Agenda
City of Springboro Planning Commission Meeting
Wednesday, May 12, 2021, 6:00 p.m.

Background Information & Staff Comments
City of Springboro Planning Commission Meeting
Wednesday, May 12, 2021, 6:00 p.m.

Site Plan Review, 285 South Pioneer Drive, Tooling Zone, building addition

General Plan, Easton Farm, 605 North Main Street, from R-1, Estate-Type Residential District, to PUD-MU, Planned Unit Development-Mixed Use, retail and residential development

Figure 6: Easton Farm Connecting Roads

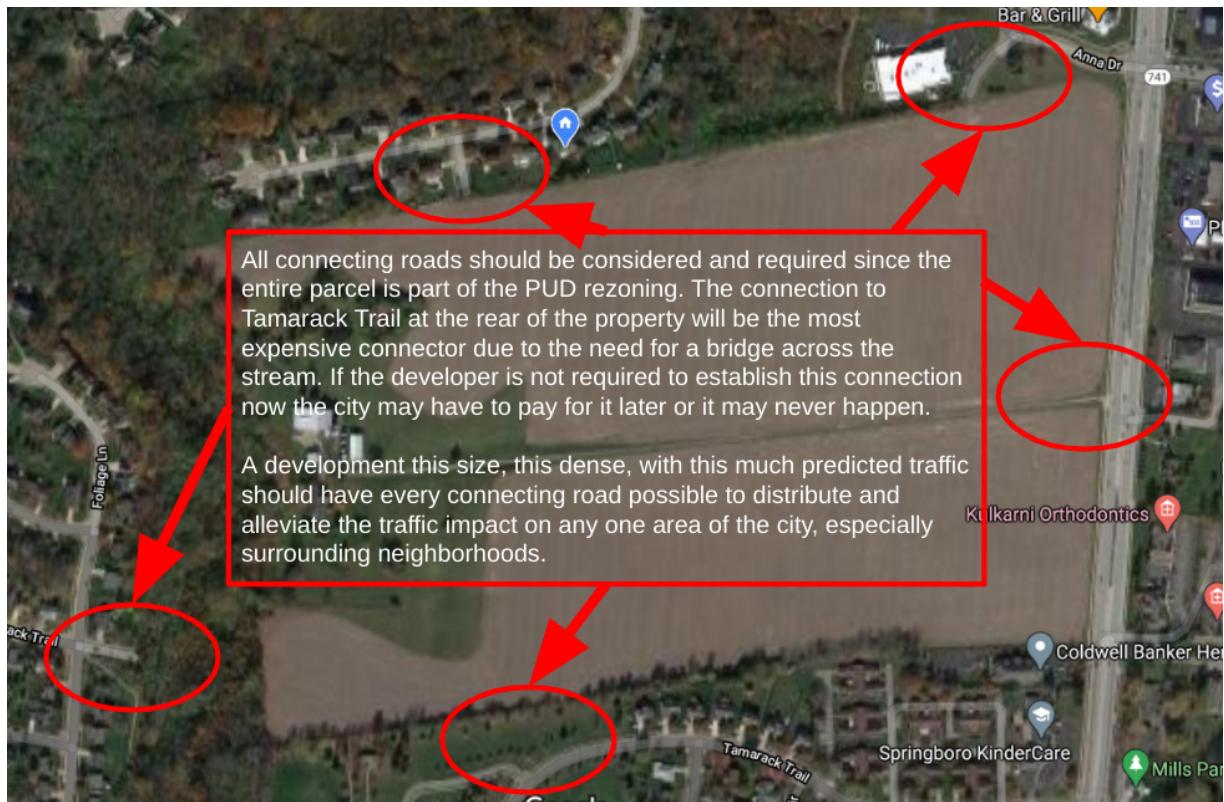
- The 2021 Plan includes the entire Easton Farm parcel in the rezoning application. It is recommended the city require the developer to make a connection between Tamarack Trail (the stub street in the Royal Tamarack subdivision, not the street feeding into North Park). This connection would alleviate the traffic congestion to surrounding neighborhoods and provide a connection to the arterial Clearcreek-Franklin Road. It is a detriment to the city and local neighborhoods to not connect all local streets and it is wise to include this cost in the development (a bridge will be required to Tamarack Trail and the city will likely not want to pay for it later - and if it is not developed as part of this development it may never be developed).

Table 2: Comparison of Recent Easton Farm Development Plans to Current Zoning

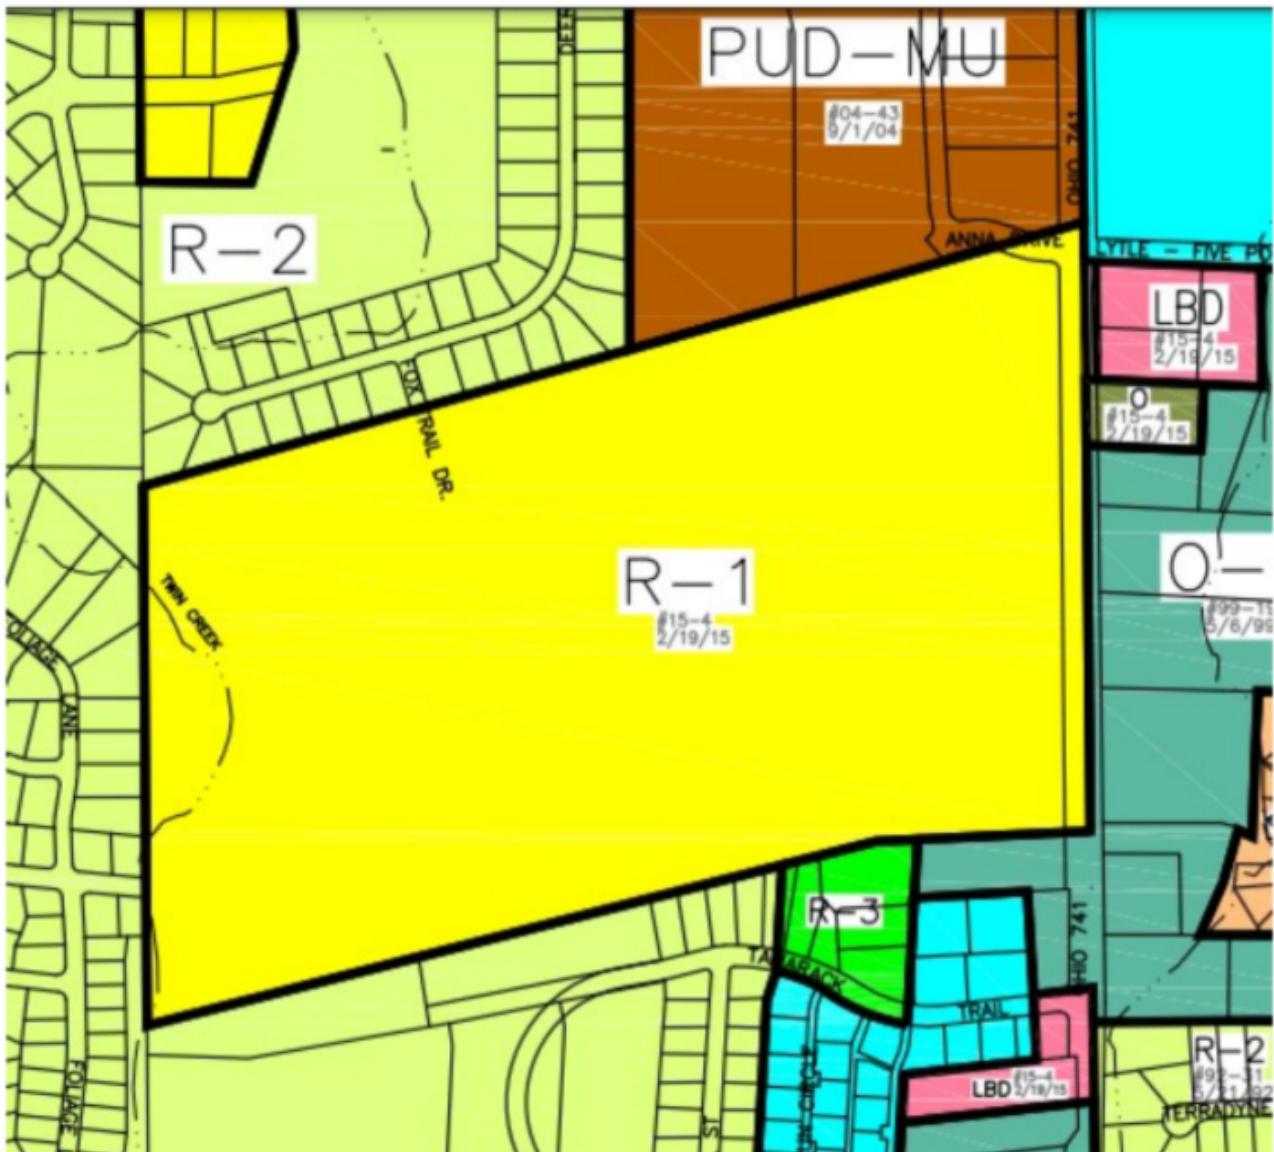
This density in the 2021 plan is not only higher than the 2017 plan, but continues to exceed the current R-1 zoning for the Easton parcel of 2 units per acre. Table 2 shows the density of the Easton Farm plans compared to current zoning, which can also be viewed in Graphic 1.

Reference	Overall Density	Comments
2017 Easton Farm Plan	6.66 u/ac	Recommended by city for denial due to high density , withdrawn plan (25OCT2017) density cited.
2021 Easton Farm Plan	6.83 u/ac, as listed OR 7.08 u/ac, based on 599 unit total on page 11 of the plan (not including independent living units)	This plan has a <u>higher density than the 2017 plan</u> . NOTE: The submitted plan density calculation may be inaccurate. The 6.83 u/ac calculation is based on 577 units, but page 11 of the 2021 plan (reference 8) states there are 599 units not including the independent living units. Page 54 of the plan states there are 577 units not including independent living. It is unclear which number is accurate. If independent living units are included, the density is likely even higher.
Current Easton Farm Zoning	2.0 u/ac	Current zoning is well below the proposed density.
